**ENVIRONMENTAL
IMPACT REPORT
FOR THE SPRING
TRAILS SPECIFIC
PLAN**

SCH NO. 2009111086

**CITY OF SAN
BERNARDINO**

**THE PLANNING
CENTER | DC&E**

Figure 5
Existing Morning Peak Hour Intersection Turning Movement Volumes

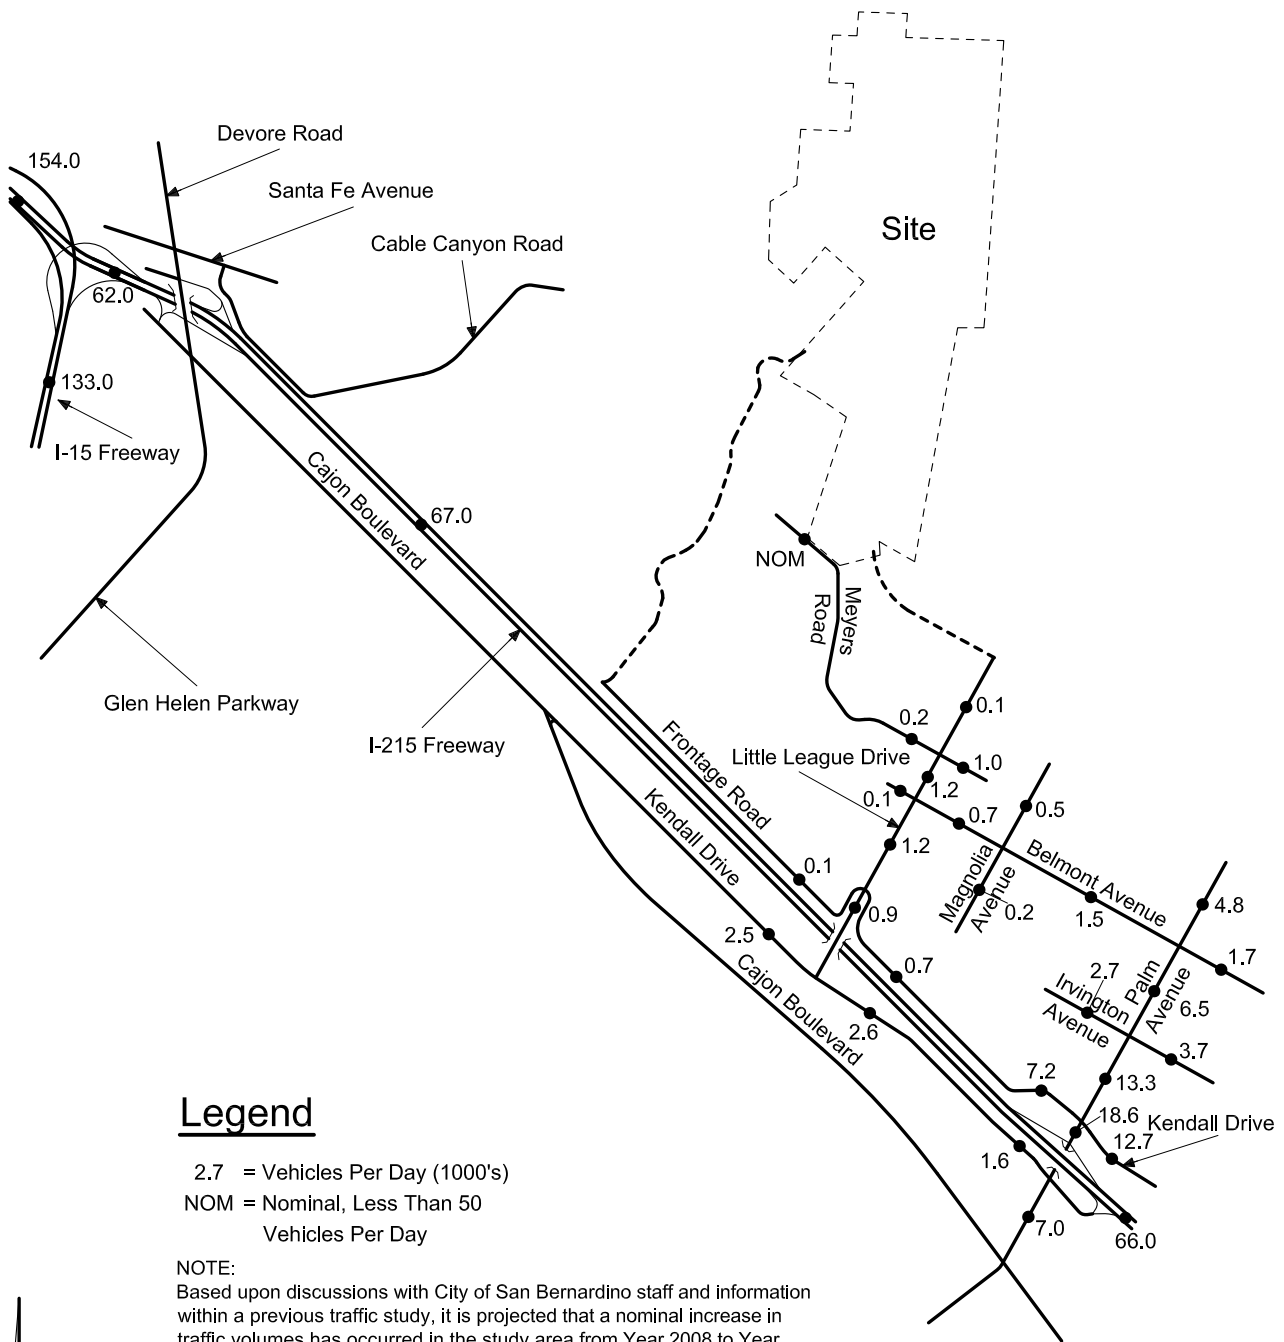
Table 1, Figures 4, 5, and 6; there are two different years of traffic data collected for the proposed study. Label and verify the existing year (i.e. 2008 or 2009).

Intersection 4, Kendall Drive at Little League Drive: The existing morning volumes on Figure 5 do not match the count sheets.

A2-1 Table 1 and Figures 4, 5, and 6 of the traffic study have been revised to indicate the existing year as a footnote or in the legend (see Appendix A of this FEIR). In the Draft EIR, Table 5.14-2 and Figure 5.14-5 have been revised to reflect the changes. The revised table and figure are found in Section 3, *Revisions to the Draft EIR*, of this FEIR.

Figure 6
Existing Evening Peak Hour Intersection Turning Movement Volumes

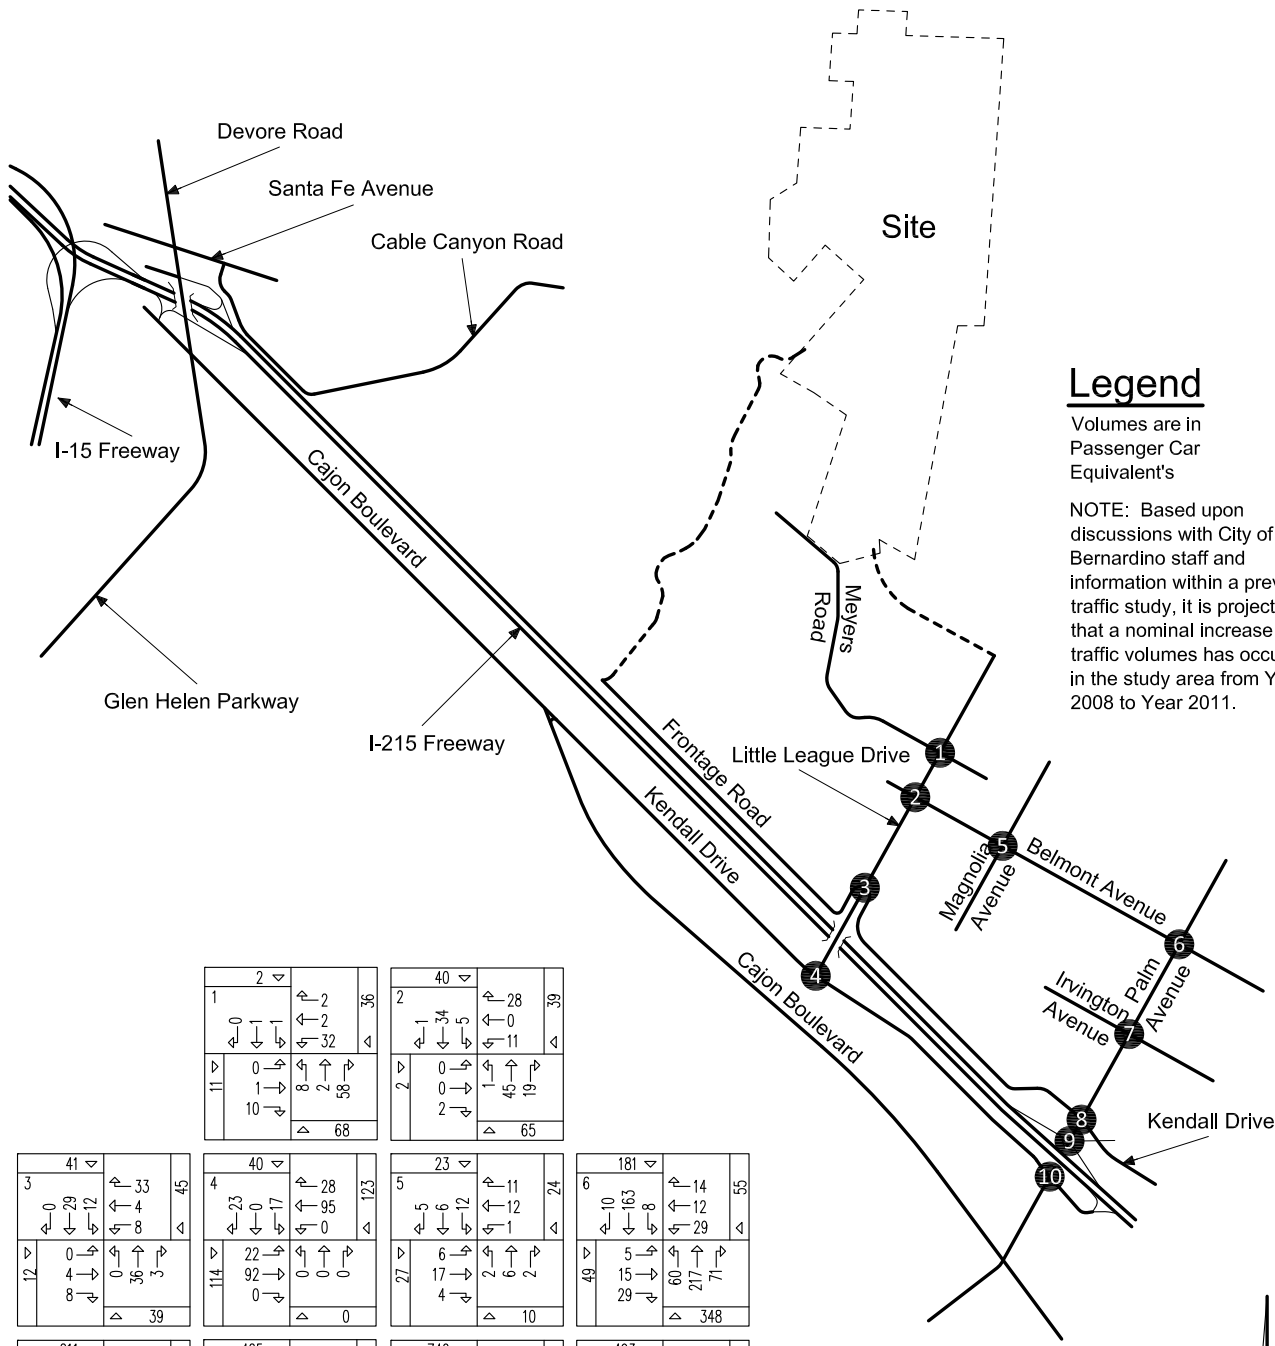
Existing truck volumes should be counted and then converted to Passenger Car Equivalent (PCE) volumes using PCE factors 1.5, 2.0, and 3.0 for 2-axle, 3-axle, and 4-or-more-axle trucks, respectively. Please verify the PCE calculations factor in Appendix B (traffic count worksheets), should be reflect in figures 5 and 6.

A2-2 Existing intersection traffic conditions were established through morning and evening peak hour traffic counts obtained by Kunzman Associates, Inc. from October 2008 (see Appendix B of the traffic study) and the resulting Passenger Car Equivalent traffic volumes (see Appendix C of the traffic study) are shown on Figures 5 and 6 of the traffic study, respectively. The revised traffic study figures are in Appendix A of this FEIR.
